North Campus Faculty Housing Phase II  
Project No. FM110407L/986315

**Addendum No. 6**

ADDENDUM NUMBER 6  
to the  
CONSTRUCTION DOCUMENTS

**BUILDING 400B: SECTIONS**

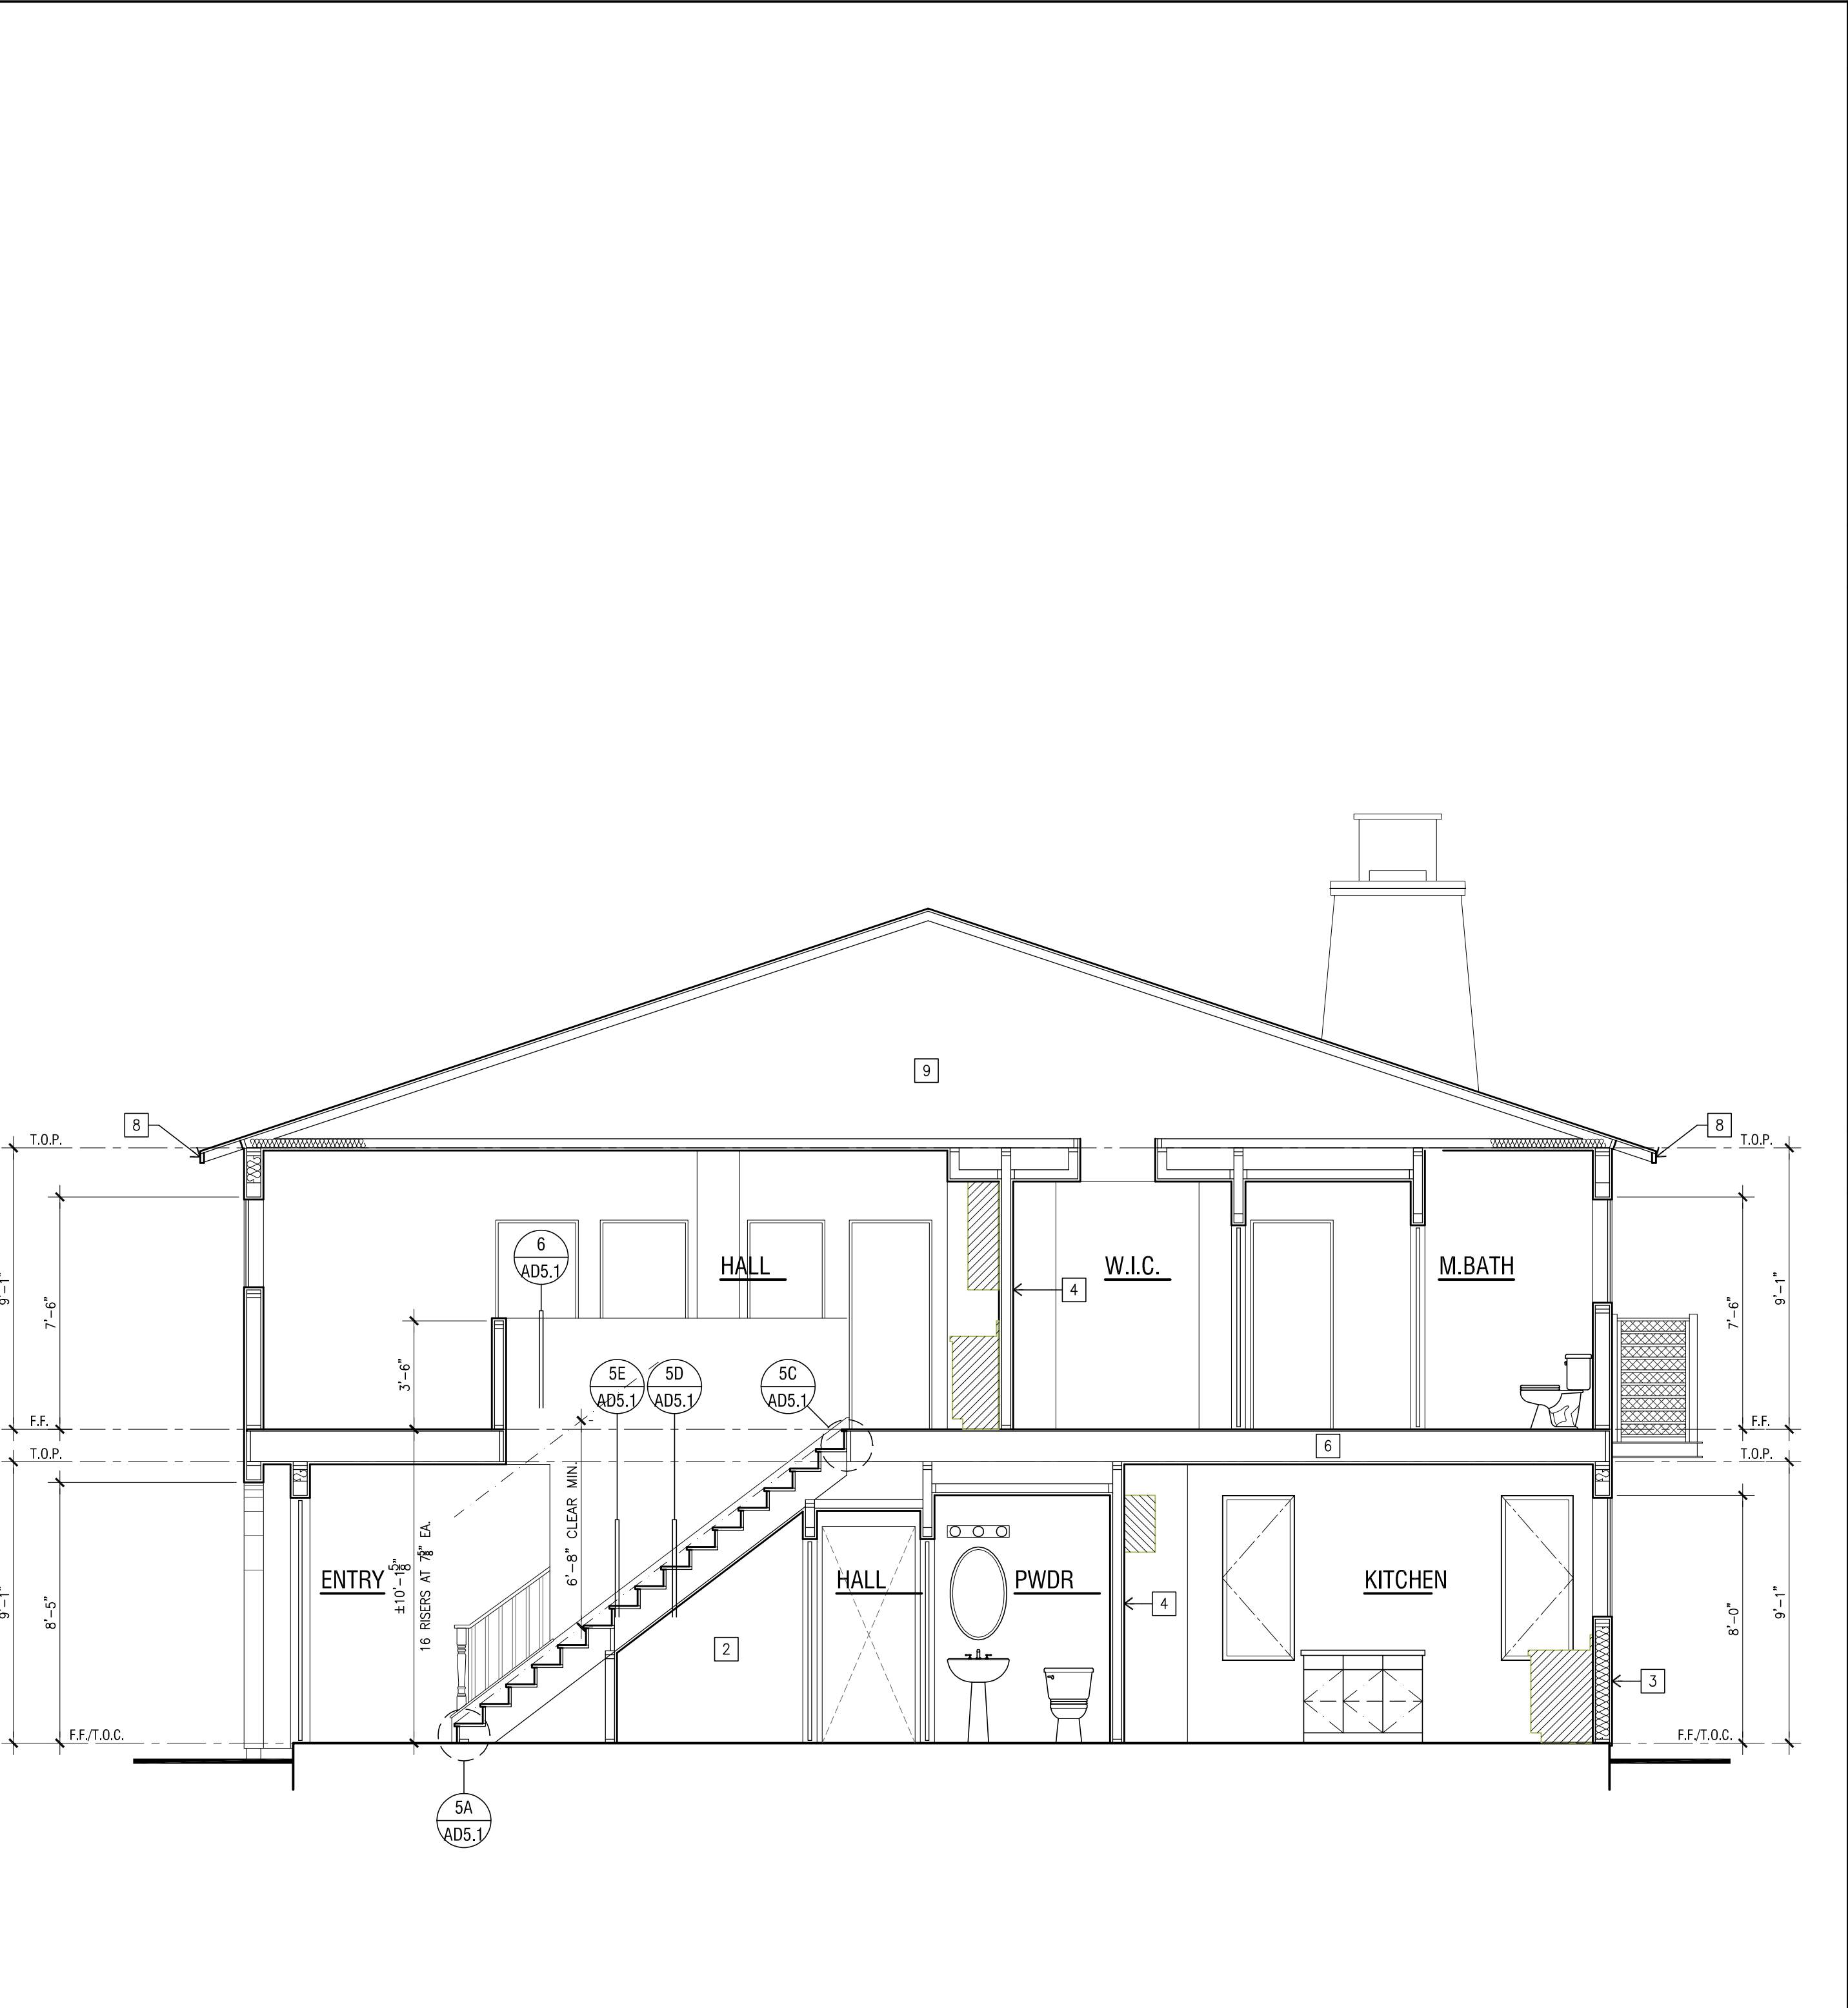
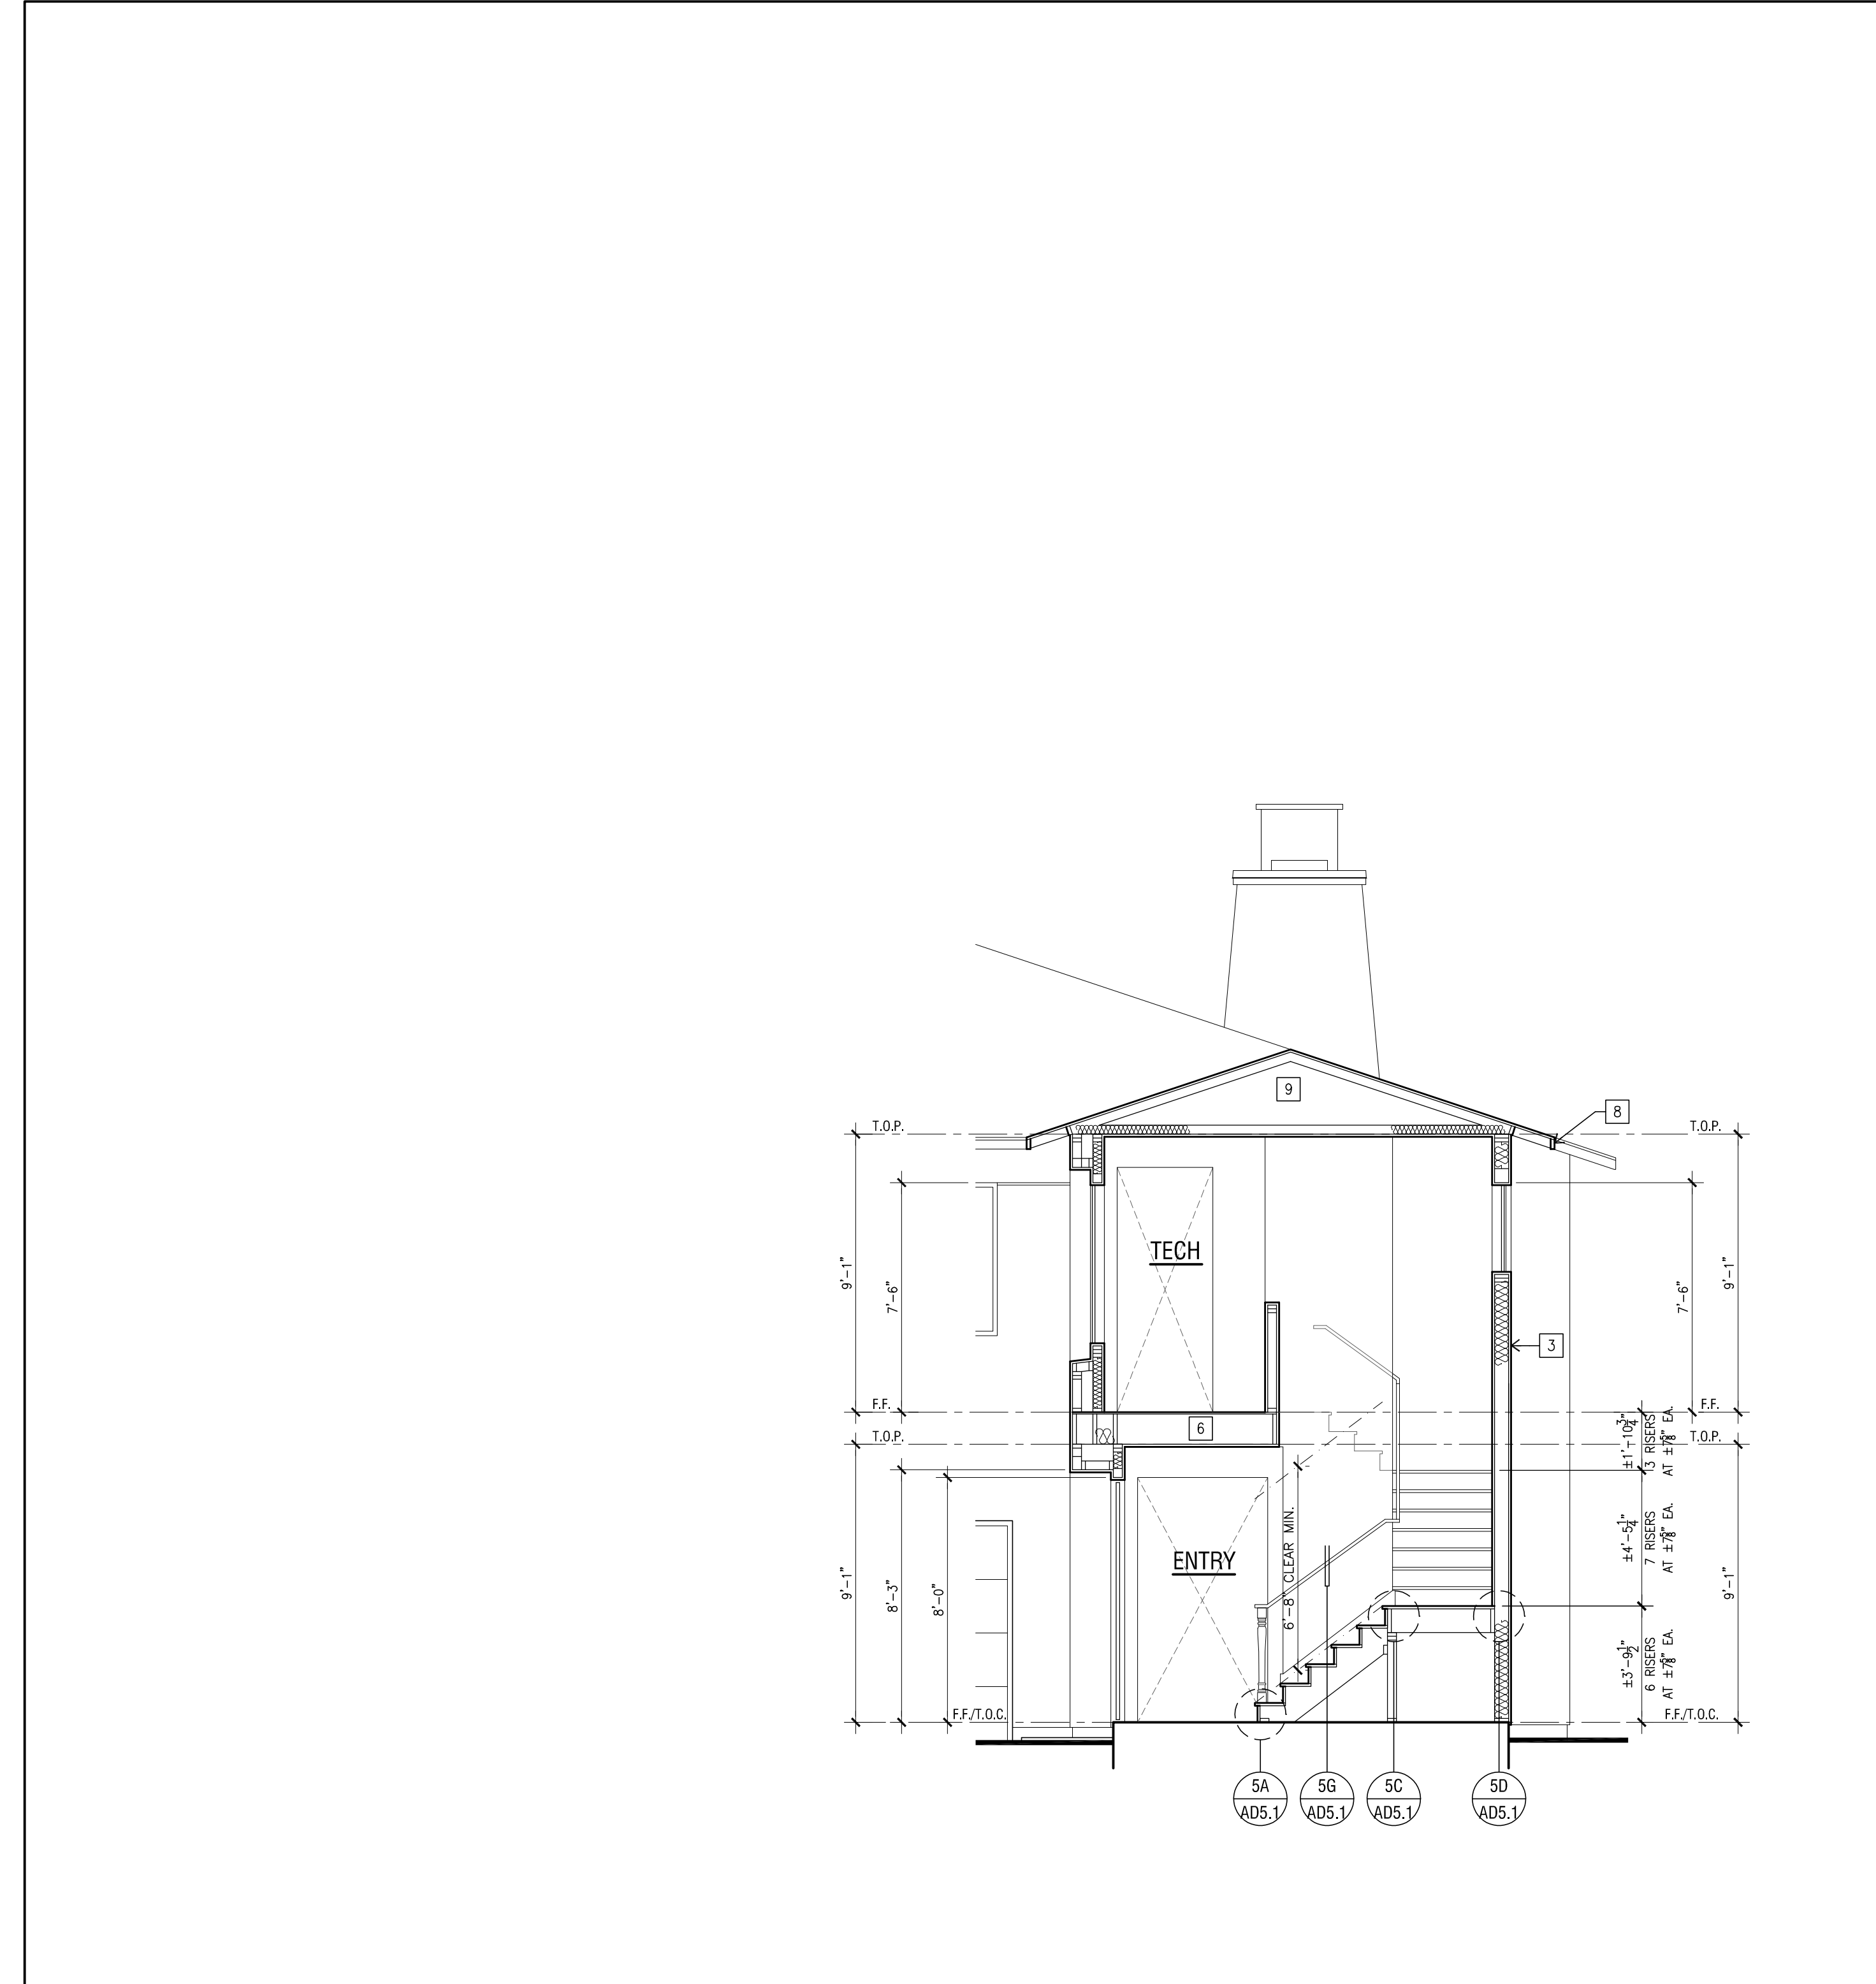
1. **Add** the attached Architect Sketches 1 of 8, dated 9/23/11.  
Sketch 1 of 8 Building 400A: Sections  
Sketch 2 of 8 Building 400B: Sections  
Sketch 3 of 8 Building 500B: Sections  
Sketch 4 of 8 Building 600A: Sections
